Model: Apollon-C1	Date: 21-Jul-06	No.: RB222001b
-------------------	-----------------	----------------

Subject: Firmware Release History (Web Uapl)		Prepared by: T.Kiyohara	
From: 1st Tech. Support Sec. Service Support Dept.			
Classification:	<input type="checkbox"/> Troubleshooting	<input type="checkbox"/> Part information	<input type="checkbox"/> Action required
	<input type="checkbox"/> Mechanical	<input type="checkbox"/> Electrical	<input type="checkbox"/> Service manual revision
	<input type="checkbox"/> Paper path	<input type="checkbox"/> Transmit/receive	<input type="checkbox"/> Retrofit information
	<input checked="" type="checkbox"/> Other ( )

Model: Apollon-C1	Date: 21-Jul-06	No.: RB222002g
-------------------	-----------------	----------------

Subject: Firmware Release History (FAX)		Prepared by: M. Kumagai	
From: 1st Tech Service Sect., MFP/Printer Tech Service Dept.			
Classification:	<input type="checkbox"/> Troubleshooting	<input type="checkbox"/> Part information	<input type="checkbox"/> Action required
	<input type="checkbox"/> Mechanical	<input type="checkbox"/> Electrical	<input type="checkbox"/> Service manual revision
	<input type="checkbox"/> Paper path	<

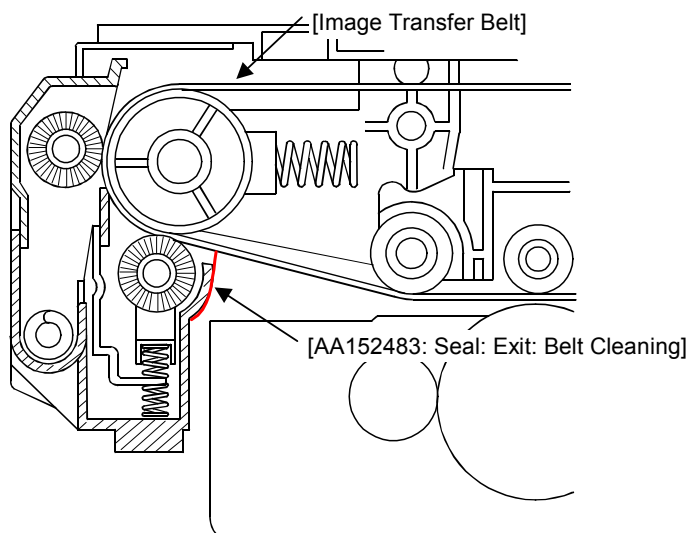
The thickness of the seal was decreased from 0.2mm to 0.1mm.

Replace the "Seal: Exit Belt-Cleaning" (New P/N: **AA152483**).

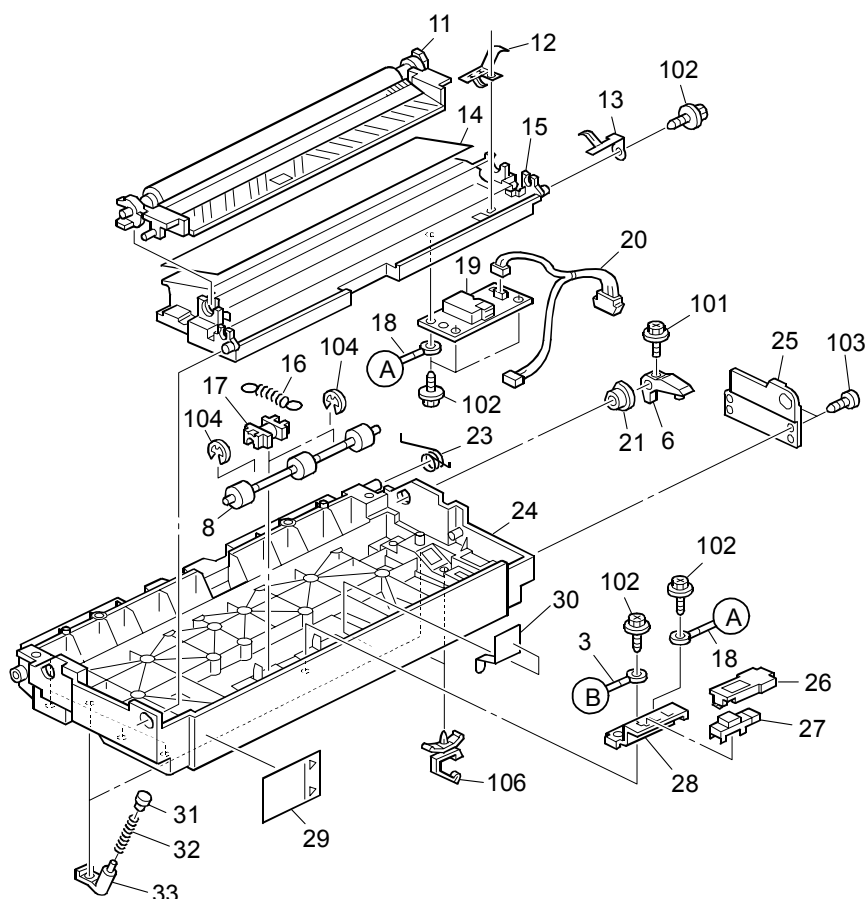
The base of the spring hook was strengthened.

Replace the two coil springs with two new plate springs (**P/N B2239004**).

**New P/N: AE040069**

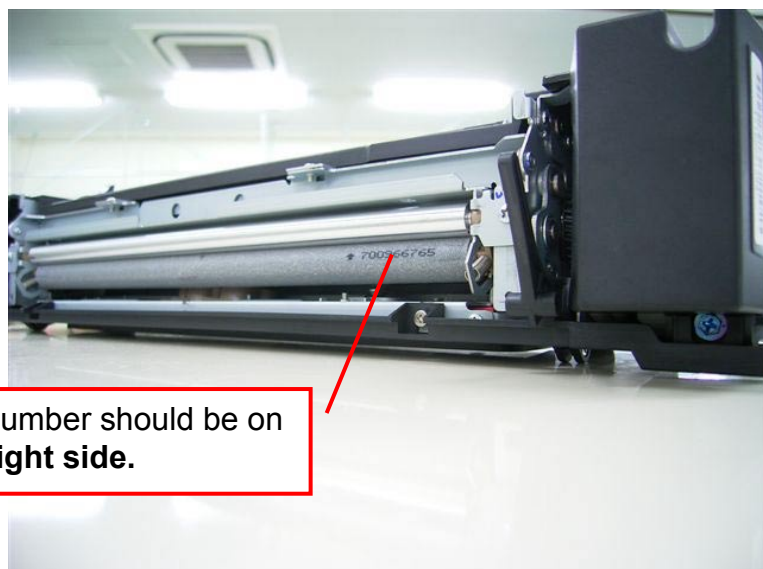
The material of the lubricant roller was changed. This new material has a higher heat resistance.

If the symptom is reported on a lubricant roller with lot number "XXXXXXX**65**" (total 9 digits), replace the lubricant roller with the modified one.

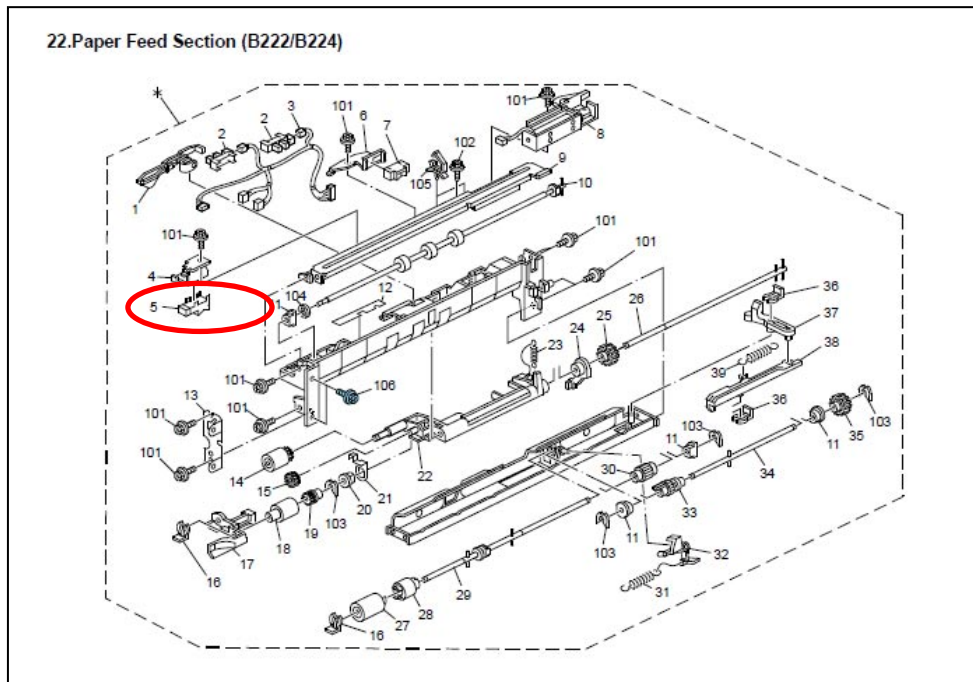
The vendor changed the soldering method to ensure the connection is strong enough.

Replace the paper feed sensor (P/N AW010128) with one that is **not** from lots FF08 – FK26. (06.06.08-06.09.26)

## 41.Electrical Section 3 (B222/B224)

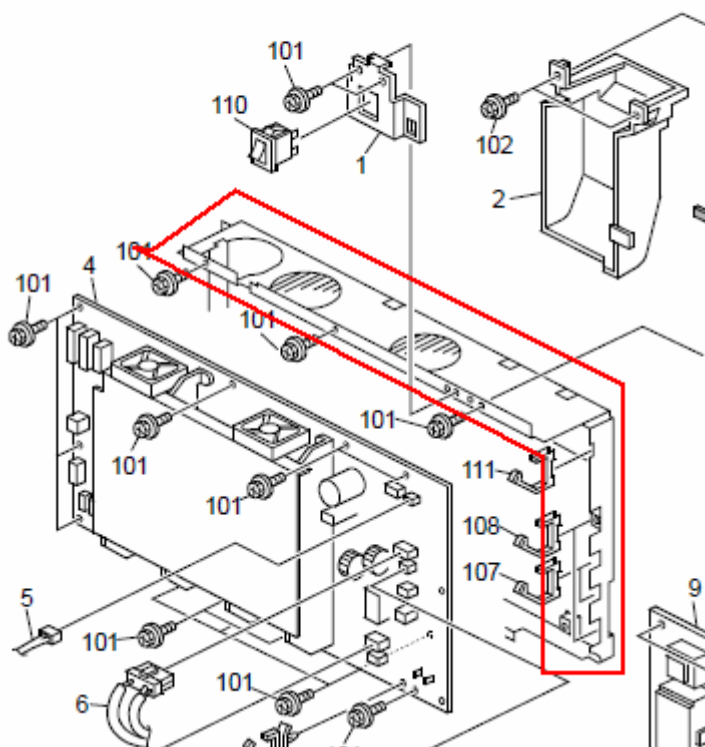
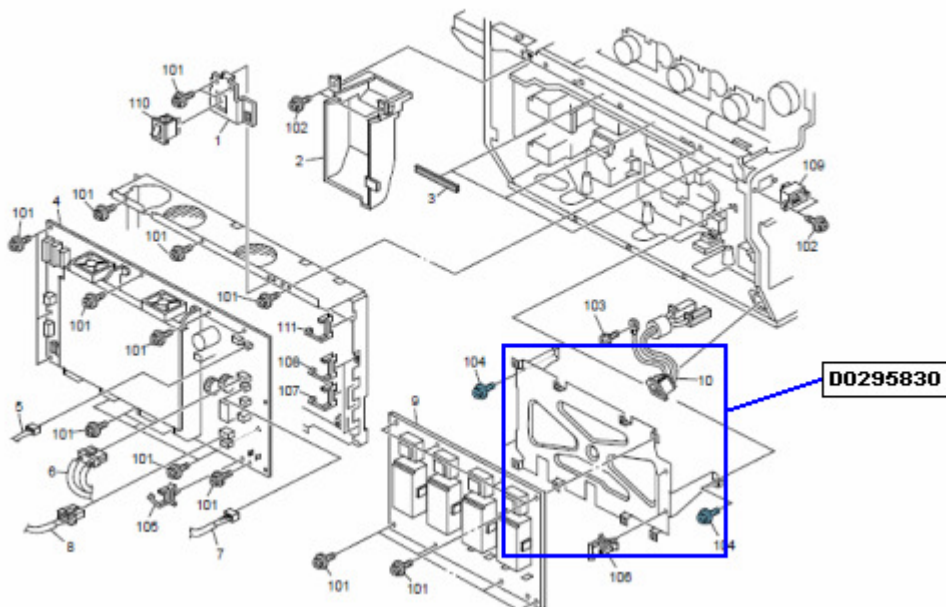
**Change / Reason:** The power pack bracket was added to the parts catalog.

[A]: Original exit cover

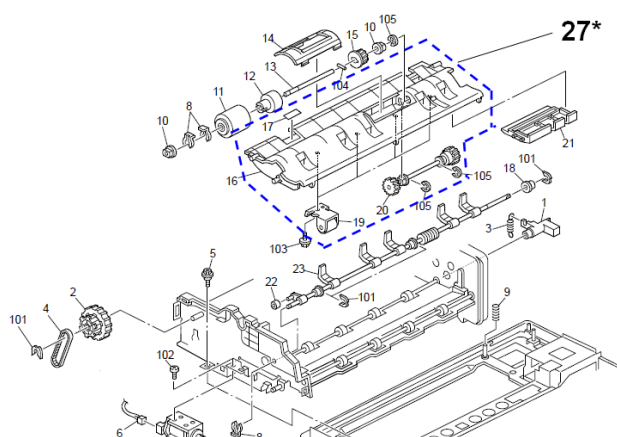
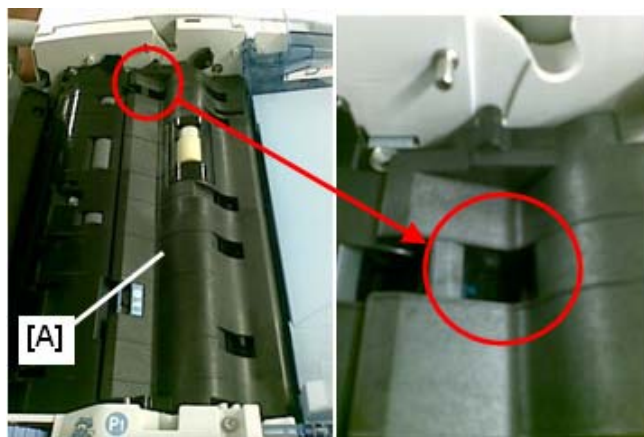
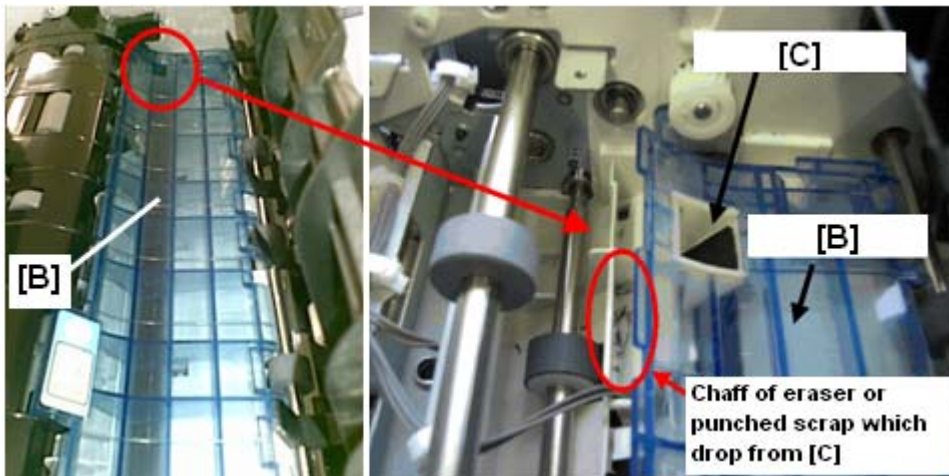
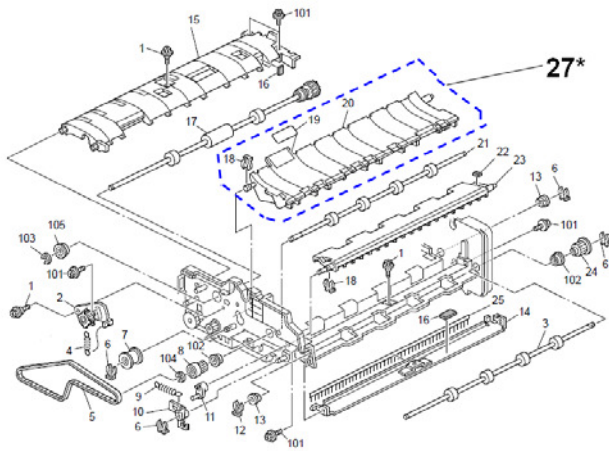
Replace the original exit cover and reverse cover with the following new parts.

[B]: AW020190 (PHOTOINTERRUPTOR)

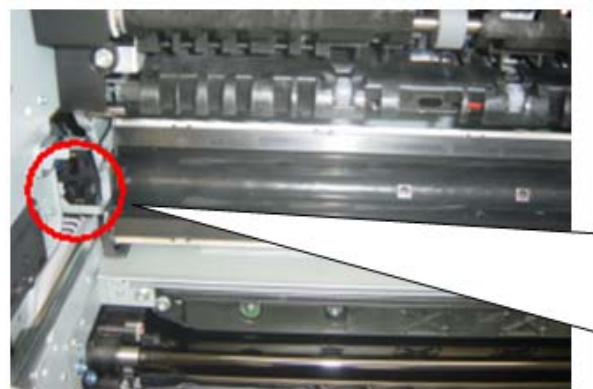
**Note:** The shapes of the above parts were changed to improve the reliability of contact between the encoder and sensor.

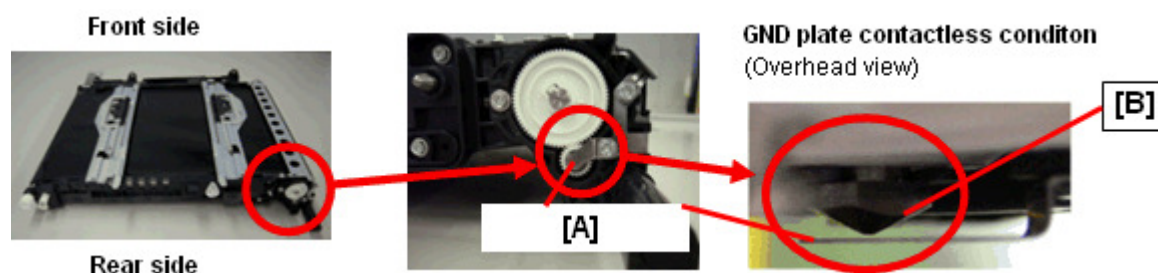
Sometimes, the GND plate at the rear side of the ITB cleaning unit [A] does not touch the lubrication application shaft [B]. As a result, a minor electrical leak occurs, which can trigger electrical noise. Sometimes, this effect appears as lines at 110mm intervals.

Areas of the PCU that have changed in shape:

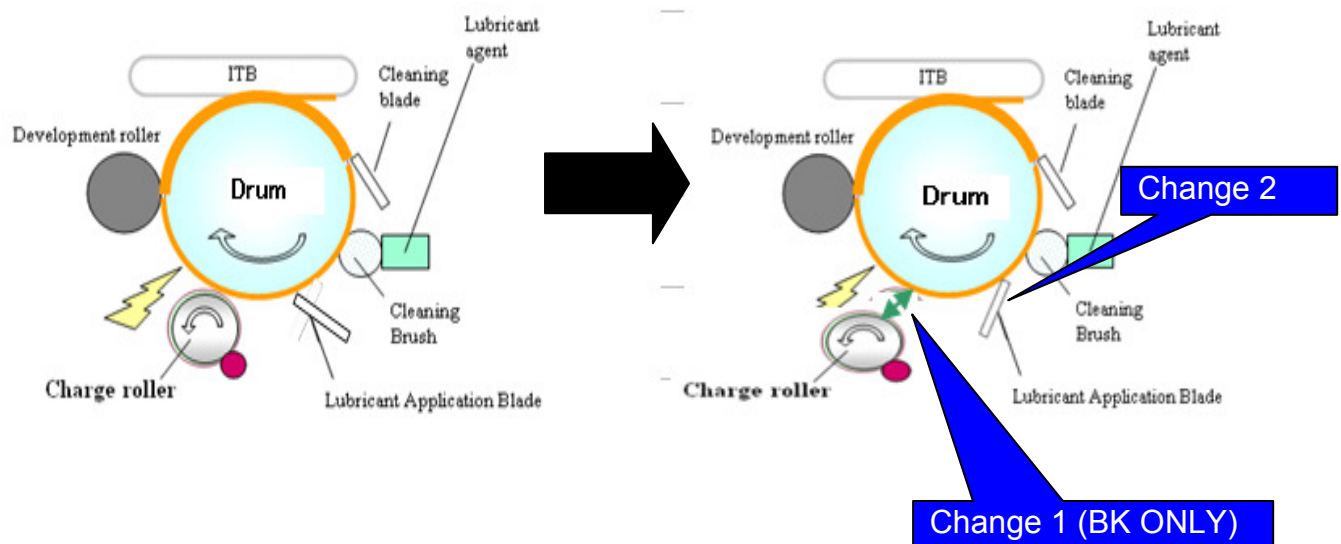
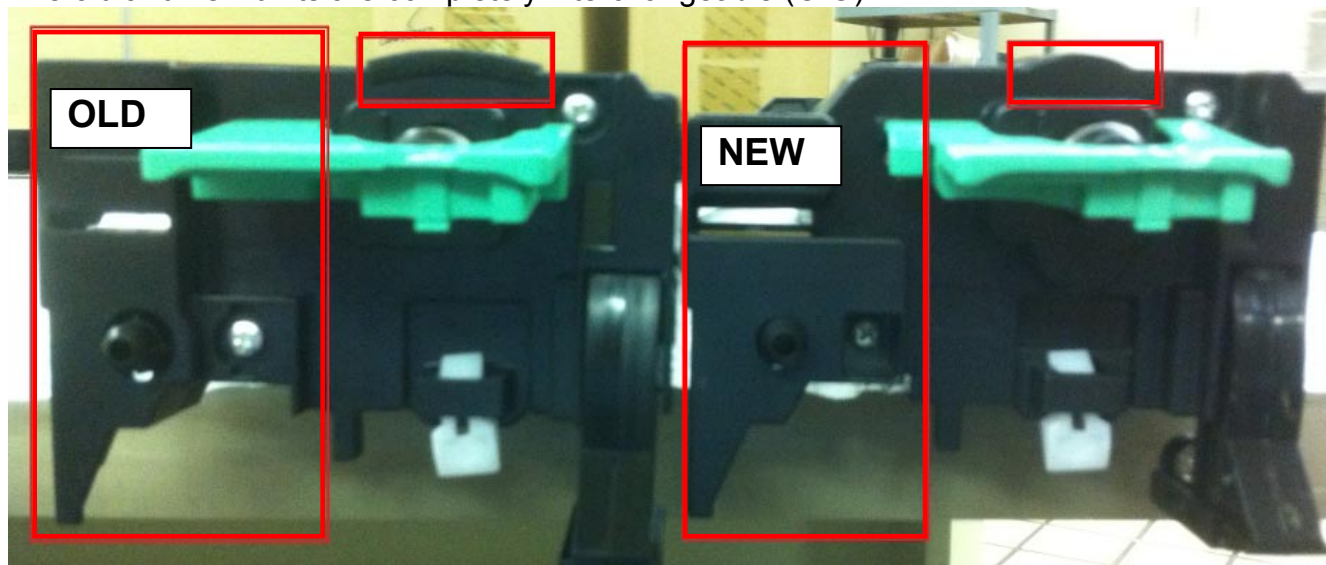
## Change:

The old and new units are completely interchangeable (O/O).
